Summary for DRH11-00133

Glenn Levie requests approval to construct a 108 unit apartment complex comprised of one and two bedroom and live/work units in four-stories on property located at 1005 W. Royal in an R-OD (Residential Office with Design Review) zone.

Planning Division Staff Report

DR-1

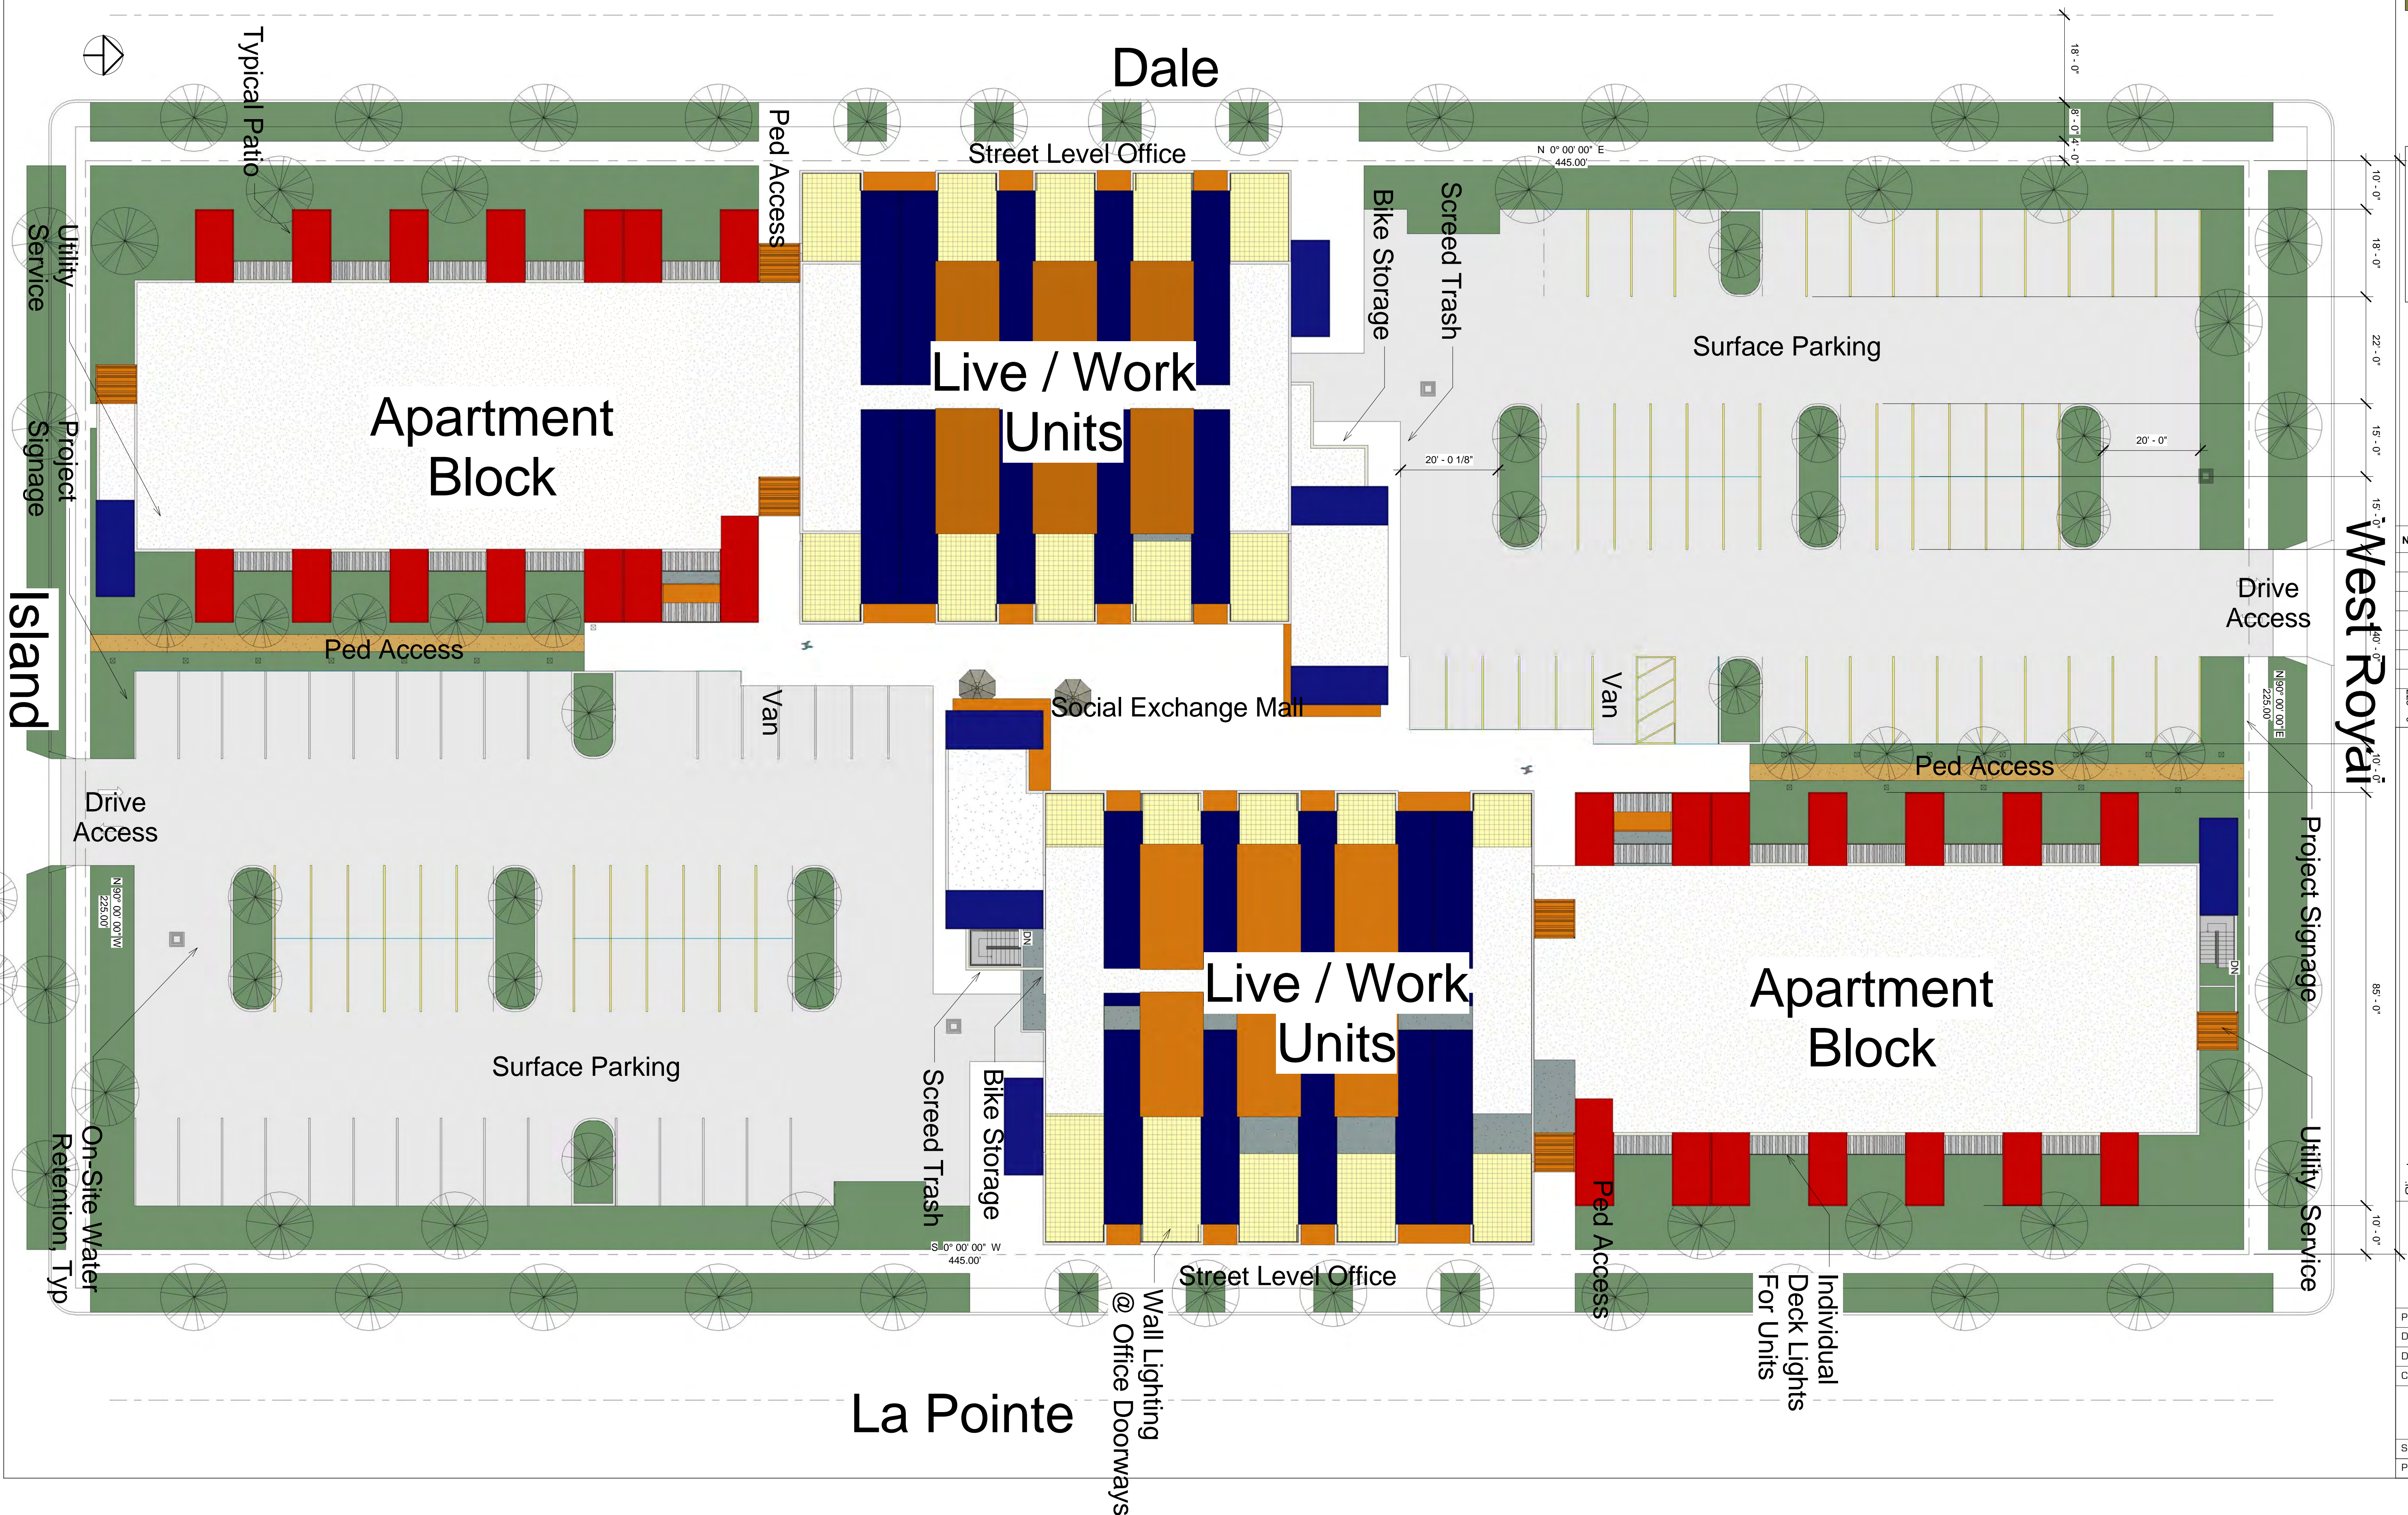
The buildings are oriented to Dale and La Pointe with parking for approximately 38% of the street frontage. The access to the surface parking lot is located approximately mid-block on Royal and Island. The access point is 22’ in width and doesn’t show the radius and intersection with the streets. ACHD in their memorandum to the City and copied to the applicant has stated the access point will be required to be constructed as a 20’ wide driveway.

The site plan and parking counts have been included in the staff report and are shown on the drawing indicated as sheet "DR-2". There is a combination of surface parking and covered

The plans submitted on July 21, 2011 meets these parking lot layout requirements and will provide for softening of the concrete along with the vegetation at the perimeter.

- g. The sidewalk adjacent to Royal shall be detached a minimum of 8' and have an 8' sidewalk.
 - h. A minimum of five different tree species shall be used for the site. No species is allowed to make up more than 40% of the tree plantings.

- r. The project shall provide a total of 162 parking stalls shall be provided. A parking reduction of 11 stalls has been granted with this application.

Ground Level / Landscape Lighting	
Project number	Project Number
Date	Issue Date
Drawn by	Author
Checked by	Checker
DR-2	
Scale	1/16" = 1'-0"
Plot Date	7/21/2011 1:36:48 PM

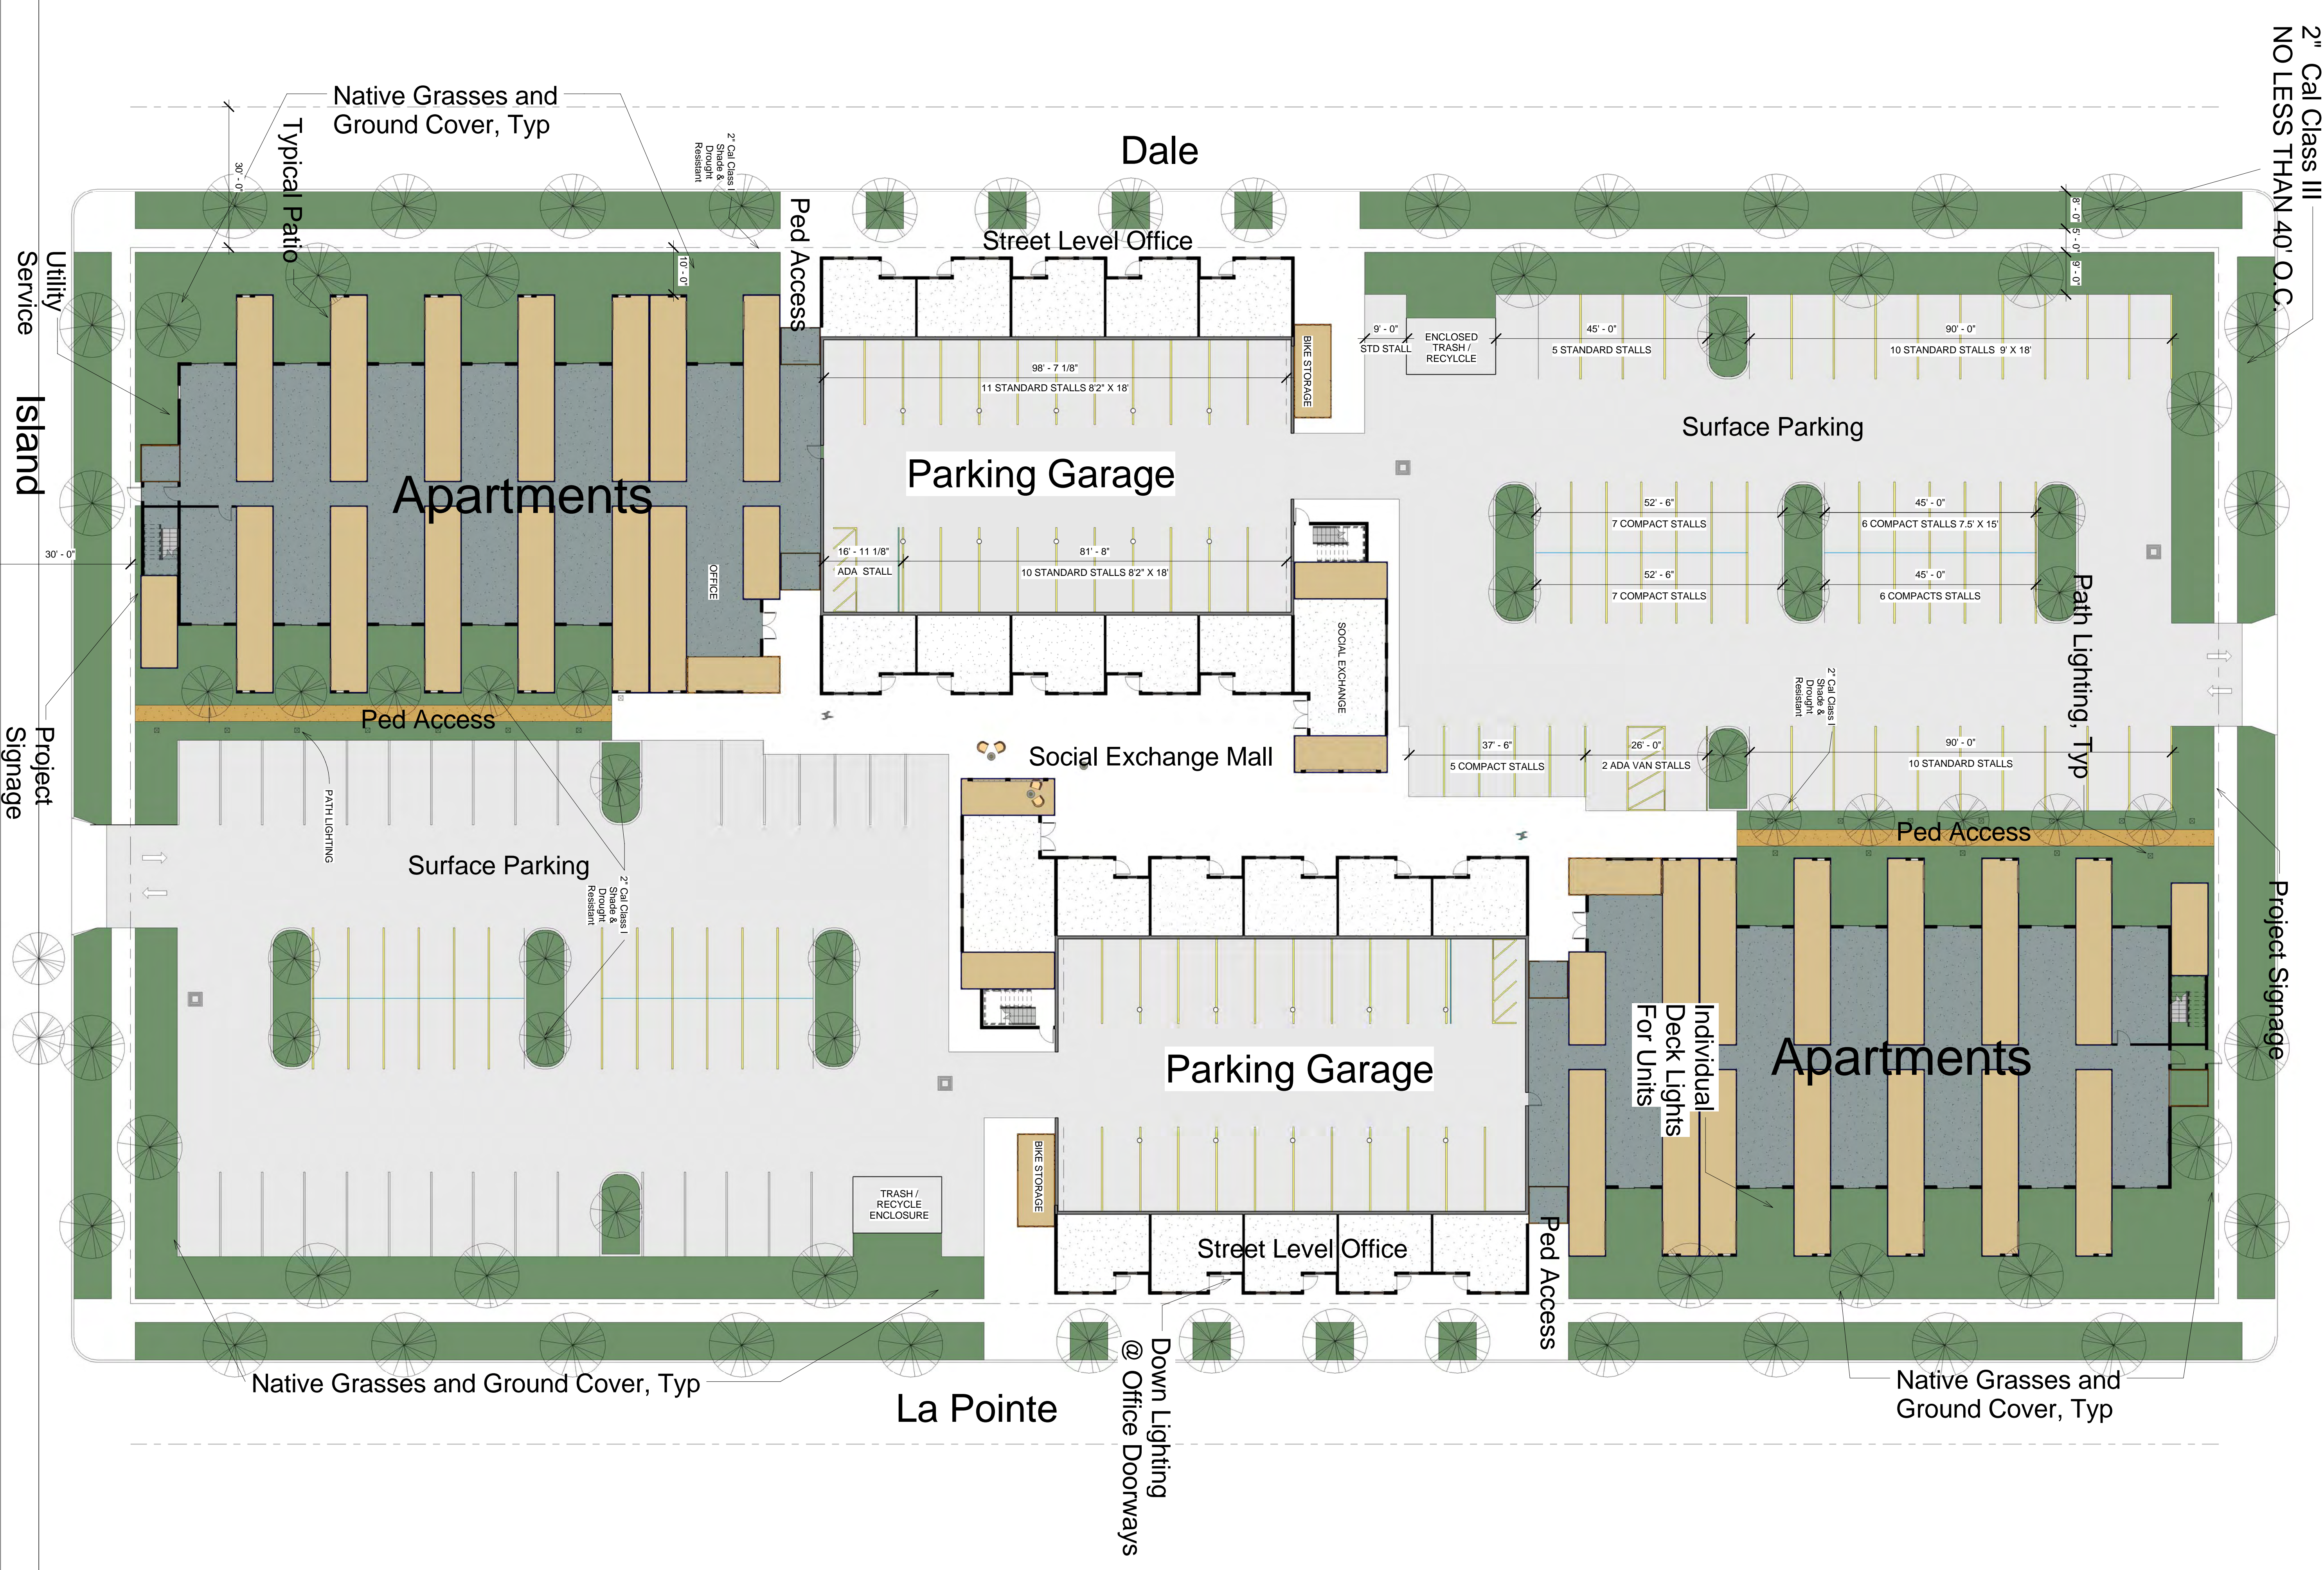
The site plan indicates there will be individual deck lights for the units, there will be wall lighting at the office doors and there will be typical path lighting. As a condition of approval it will be required that cut sheets with heights for the pathway lighting are supplied prior to submittal for a building permit.

Planter beds or some kind of vegetation should be installed at the base of the building to soften it. The planter beds should be indicated on the landscape plan with the number and species of each specimen called out.

- a. Provide cut sheets for each of the building mounted lighting fixtures. Show locations on the building and indicate number to be used.
 - b. Provide a cut sheet for the pathway lighting fixtures. Indicate height and number of fixtures to be used.
